Gildan Shahriyar Fabrics Ind. (11479)

Palashbari, Ashulia, Savar, Dhaka

10.August.2014

Identified Priority 1 Concerns

5th Priority 2 Concern

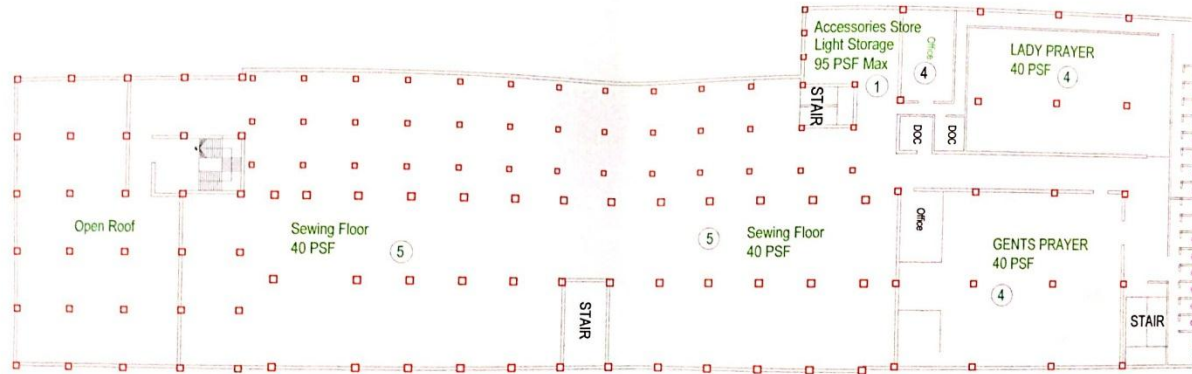
Steel and timber detailing to roofs over stairwells in main factories.

Item No.	Observation	Recommended Action Plan	Recommended Timeline
9	Priority 2 - Steel and timber detailing to roofs over stairwells in main factories.	Carry out Engineering Assessment on steel roofs around the main factory to determine what strengthening works are required.	6-weeks
10	Priority 2 - Steel and timber detailing to roofs over stairwells in main factories.	Carry out recommendations highlighted in Engineering Assessment.	6-months
11	Priority 2 - Loading plans require displaying at all upper floors.	Print loading plans out for all buildings and display around the buildings as required.	6-weeks
12	Priority 2 - Loading plans require displaying at all upper floors.	Ensure that the loading plans are actioned.	6-months
13	Priority 3 - No waterproof membrane to concrete roofs.	Cover the concrete roofs with a suitable waterproofing membrane, e.g. waterproof screed.	6-months
